INDEPENDENT EXPERT ADVISORY PANEL FOR MINING

**MOOLARBEN COAL COMPLEX OC3
Extension Project:**

**Technical Review – Proponent
Groundwater Dependent Ecosystems
Responses to Groundwater Comments in
IEAPM Advice**

Report No: IEAPM 202508-2

Figure 1: Maximum Predicted Drawdown in the Quaternary Alluvium and Palaeochannel until end of Mining (Figure 5 from AGE 2024)

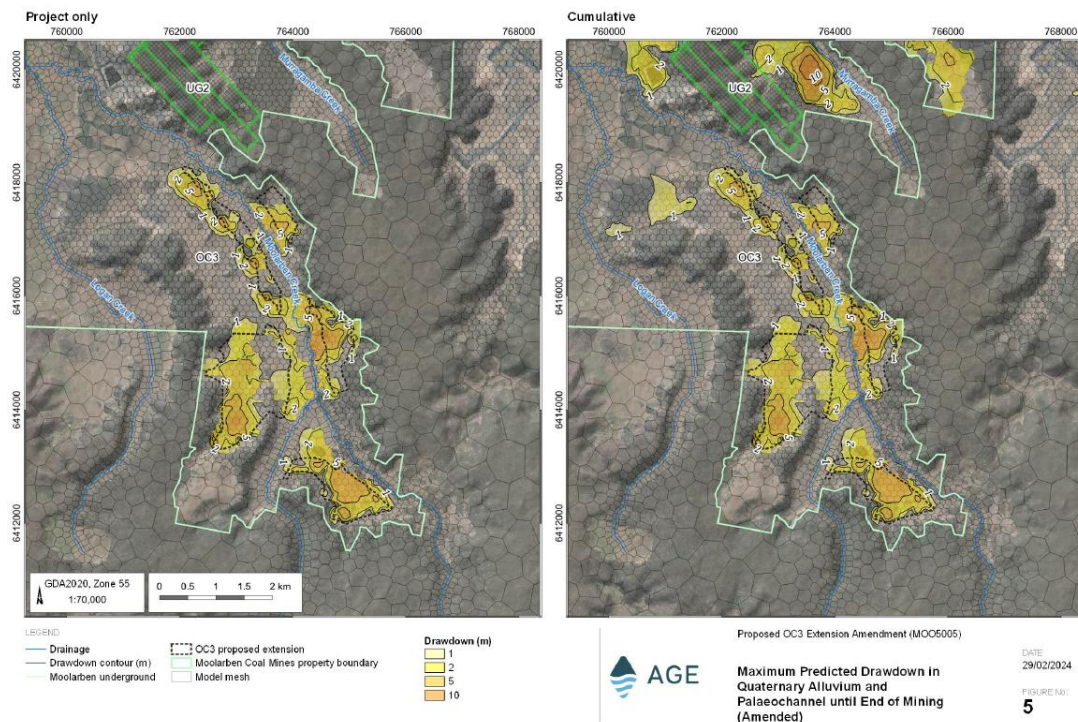
Long-term drawdown of 5-6m could dewater the alluvium and remove the availability of this groundwater to the facultative GDEs along the creek lines. It is uncertain whether the larger trees within this vegetation community could be sustained by just rainfall and soil moisture, especially during extended dry periods. There will be no ‘baseflow’ if water levels decline and shallow groundwater drains.

Figure 2: Cumulative Residual Drawdown and Mounding at the End of Recovery Period (Figure 9 from AGE 2024)

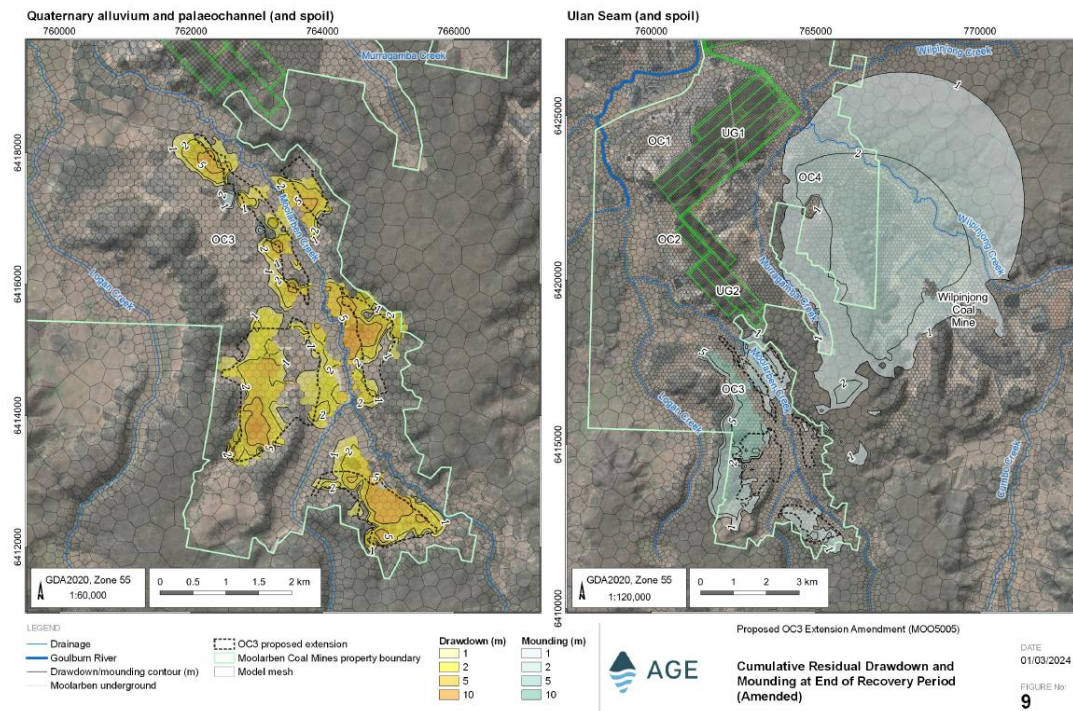
AGE (2024) predicts groundwater recovery and some mounding in the former Ulan Seam and reinstated spoil areas post-mining at the ‘end of the recovery period’ but predicts no recovery of the shallow water table in the alluvium and palaeochannel areas (Figure 9 in AGE 2024 reproduced in this advice as Figure 2). The recovery period is not defined in either AGE 2022 or AGE 2024.

The Panel has concerns about these model predictions are highlighted by the fact that:

- The recovery period is not defined (water level recovery periods are likely to be quite different for the Ulan Seam and spoil versus the shallow alluvium, palaeochannel and spoil areas).
- There is no recovery predicted in the alluvium and palaeochannel areas (see Figure 2). This figure is the same as the ‘drawdown at the end of mining’. AGE 2024 states that “*open cuts would be backfilled, which would restore pre-mining hydraulic gradients and allow water levels to recover.*” This statement is inconsistent with no predicted recovery in alluvial water levels post-mining.
